Our ref: 231064/231064-let-001/BD

Re: Permission for a Large-Scale Residential Development (LRD) at this c. 1.0 ha site of the former DELL EMC premises, Innishmore, Ballincollig, Cork. The proposed development will consist of the demolition of the existing former 2 no. storey DELL EMC building (c. 3882 sq m) and ancillary plant area, with associated site clearance works. The proposed development will provide for the 130 no. residential units, arranged in 3 no. blocks in a development ranging in height from 3 to 6 no. storeys. The development will comprise a mix of 108 no. apartments (total apartment blocks area - c. 10, 657 sqm), arranged in 2 no. blocks, providing a unit mix of 52 no. 1-bed and 56 no. 2-bed apartment units. In addition, the proposed development will provide 22 no. duplex units (total duplex block area - c. 2, 159 sqm), arranged in 1 no. block, providing a unit mix of 4 no. 1-bed, 9 no. 2-bed, and 9 no. 3 beds. Vehicular, cyclist and pedestrian access to the proposed development will be via 2 no. entrances from Innishmore Lawn (to the north east) and Mechterstadt Road (to the south west) and the development will include for pedestrian and cyclist permeability. Add

Image 1.2 – Extract from revised Daylight & Sunlight Assessment carried out by BPC Engineers indicating typical floor plan of central apartments which have been revised to dual aspect and perform amongst the highest in terms of daylight & sunlight analysis.

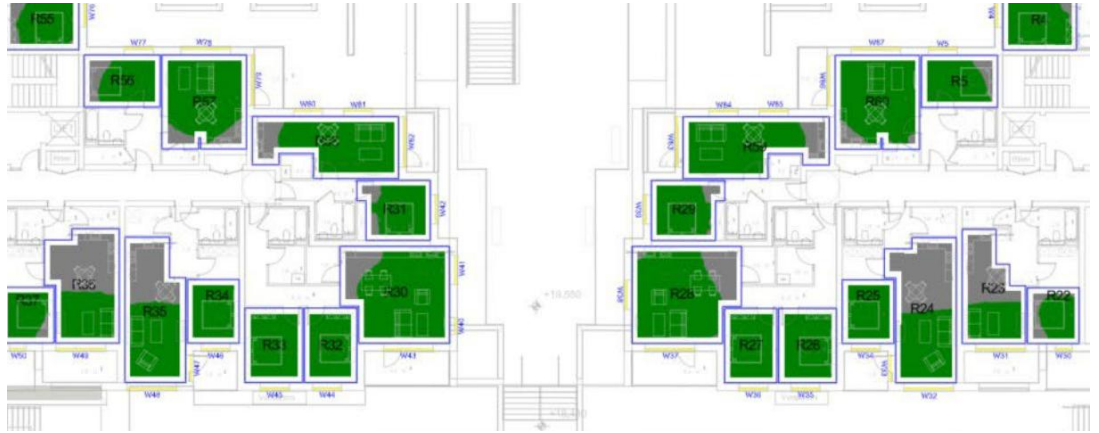
- (ii) **the omission of the type 1C apartments and balconies with the potential for increased daylight and space to the circulation spaces and an increase in the number of bedrooms to the type 1D apartments.**

We note the Council's request to omit this apartment type. The revised layout submitted as part of this response has been developed in direct response to the need to increase the daylight and sunlight performance to these apartments. As an extension of this request, a wider review of the design strategy has been undertaken with a view to increase the quality of daylight in all apartments in the scheme.

Apartment type 1C and 1D are proposed to remain as 1 bedroom apartments, but the envelope of the scheme has been adjusted on the internal courtyard side to accommodate the increased daylight to main habitable living areas. As a result, these apartment types are now among the highest performing apartment types for quality of daylight and sunlight performance, as indicated on the revised report by BPC Engineers included separately as part of this submission.

More broadly, the design strategy review of internal layouts has led to the revisions of the typical floor plan, and have improved the daylight performance of apartments across the entire scheme. Living areas are now generally proud of shaded areas or recessed balcony locations, which contribute largely to the increased quality of light within all apartments. These changes are reflected on submitted revised floor plans.

Image 2.1 –

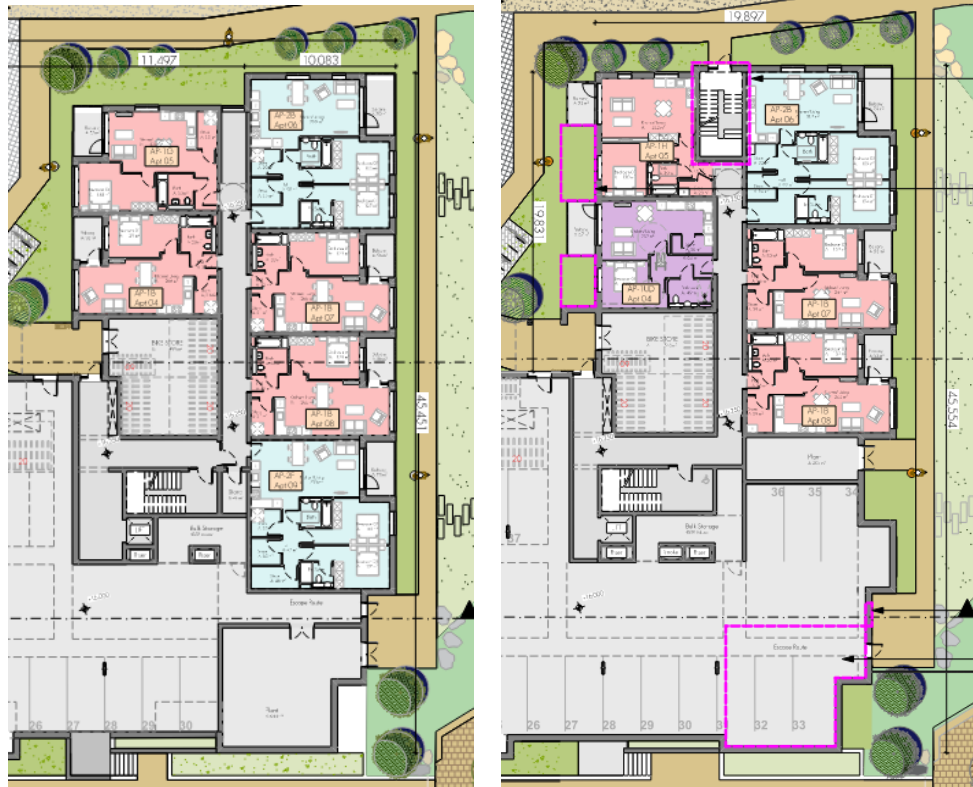
- 2. It is also considered that the car parking ratio is excessively low and that a ratio of 1 space per 0.6 units is more appropriate on site. Please submit revised drawings and details in this regard noting the reduction in unit numbers as per Item 1.**

Please see enclosed revised Lower Ground Floor Plan, drawing number 1109 which indicates the omission of the apartment in the south east corner of the eastern block. In addition to the omission of 5 no. apartments on the upper most floor, and 1 no. apartment on the Lower Ground Floor, the revised number of proposed units is 124 no., which is 6 no. less than the original 130 no.

The addition space in the enclosed carpark has been allocated to parking, which has increased to 57 no. internal car parking spaces (increased from 49 no.), and 19 no. external car parking spaces, providing a total of 76 no. spaces total, an increase of 8 no. spaces. This equates to a ratio of 0.61 spaces per unit. We trust this satisfies the quantum requested.

We note that the wording of the requested further information proposes a ratio of 1 space per 0.6 units, however we are assuming that this ratio has been proposed in error, and that the inverse is requested in keeping with the discussions and opinions received from Cork City Council during this application process. We are happy to submit any further information should clarification on this matter be required.
